Minutes of RSC Subcommittee of March 10, 2016

#### **Subject: Closing CeCPoP Issues**

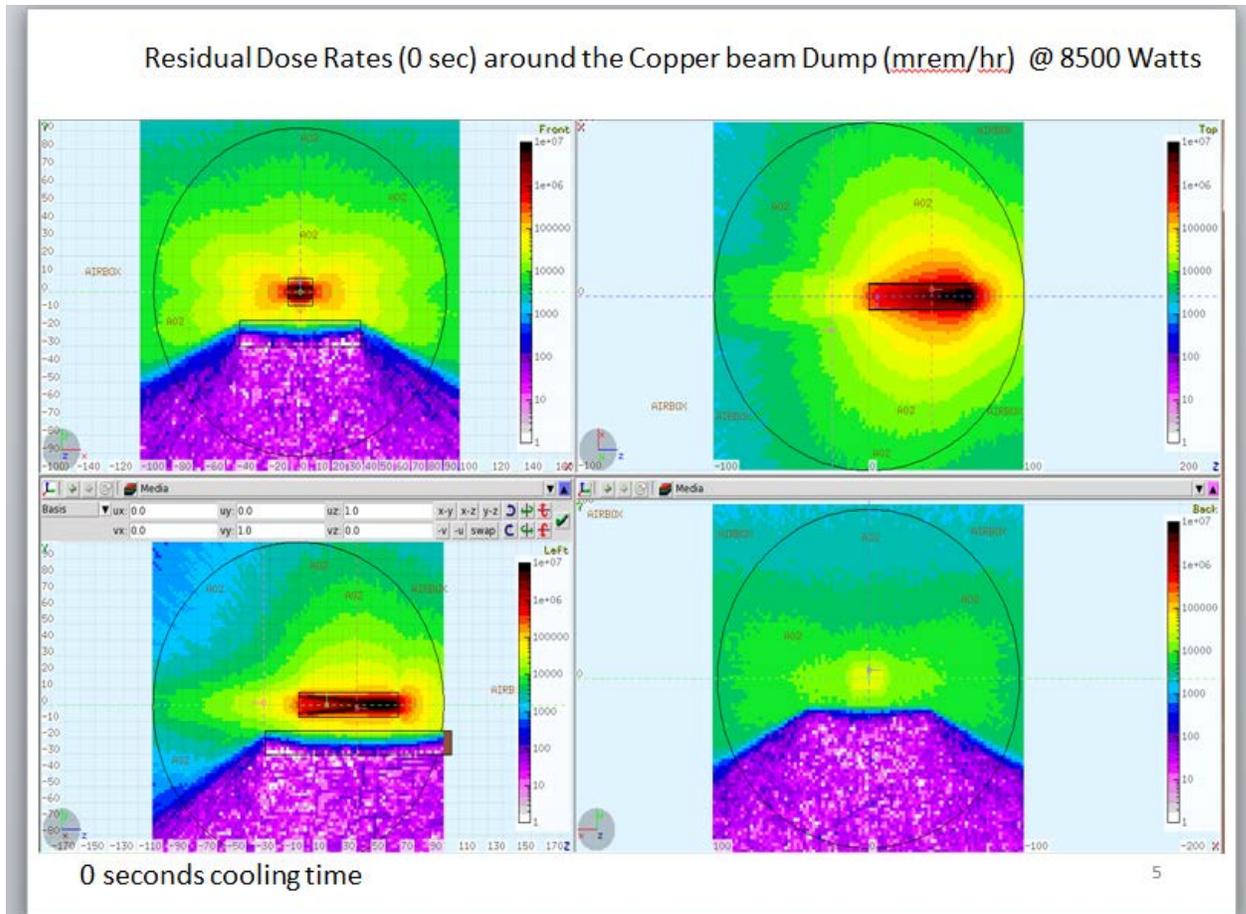
M. Benmerrouche gave a presentation on the preliminary results conducted using FLUKA for radiation issues related to the beam dump. The calculations are not final but appear to give agreement with the calculations already presented to the committee. The FLUKA code calculates the activation products in a single step rather than post processing as is required with MCNPX. The ionization in the water was approximated using a thin layer of water rather than discrete channels and is about 1%. This result is similar to the “guessimated” value used in the earlier analysis and the chair expects it to be conservative. Additional analysis will be conducted on the beam dump<sup>5</sup> using FLUKA to provide independent estimates of several of the radiation issues for CeCPoP. The results will be presented at a future meeting.

An example of the preliminary results is shown below. The figure displays the dose rates from residual activity immediately after shutdown after operating at high power. The plots are for different slices through the beam dump. The shielding around the beam dump is not

in place except for the six-inch thick steel plate that provides downward shielding and support for the beam dump and other shielding. The highest dose rates to the side are 70 rads/hr where the simple estimate with no self shielding was 600 rads/hr. The effectiveness of the steel plate for shielding the area under the beam dump is evident.
